Product Bulletin # TDS-260 Rev 1

# ABB Drives Backspin Issue – 17.01 DC Hold Parameter

Figure 1: Parameter 17.01 DC HOLD

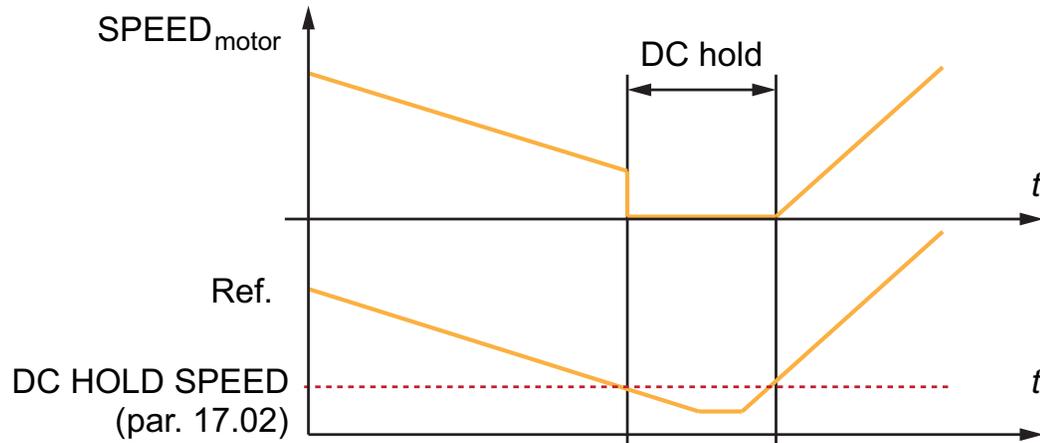
With drive parameter 17.01 DC Hold set to “1” (Active), zeroing the Top Drive RPM sets the drive to magnetizing current. This current level may be insufficient to hold torque in the drill string under load, potentially resulting in a backspin.

- A Service Bulletin to follow with changes to Top Drive ABB drive parameters.

Figure 2: Torque Ramp Down in Legacy and New UI/UX

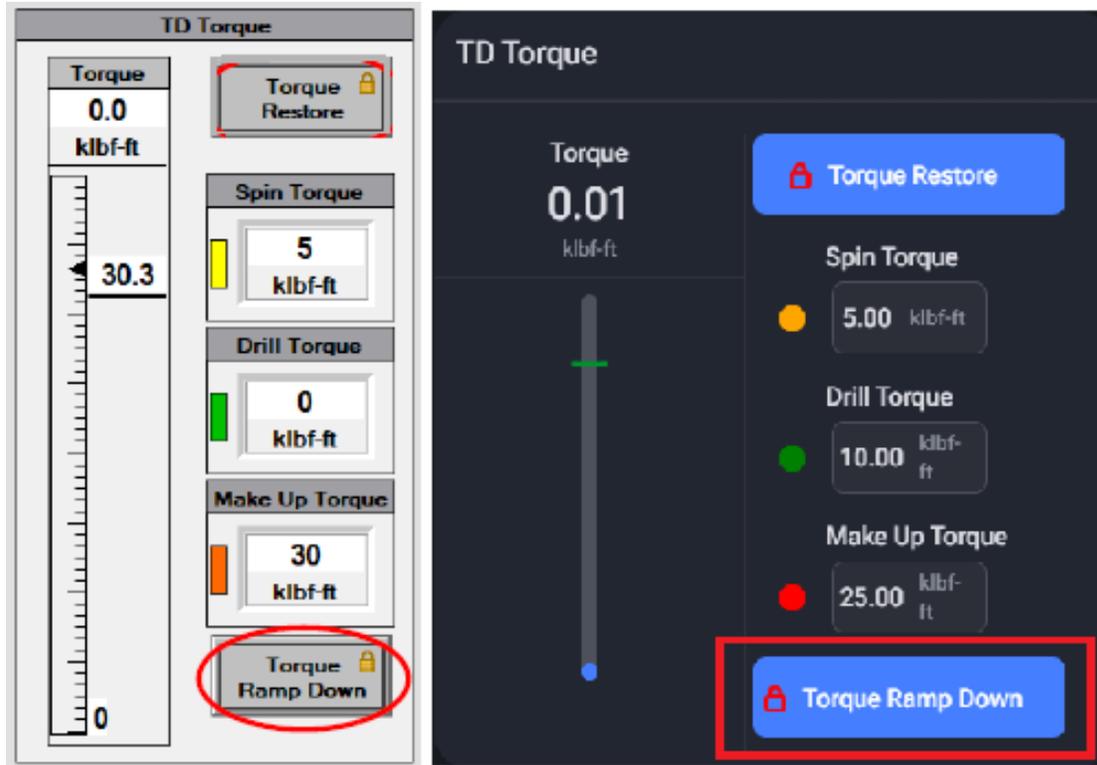
Always use the Top Drive Torque Unwind feature to ramp down torque before setting slips. (Reference: [Top Drive Torque Unwind Procedure: Bulletin TDS-133](#)).
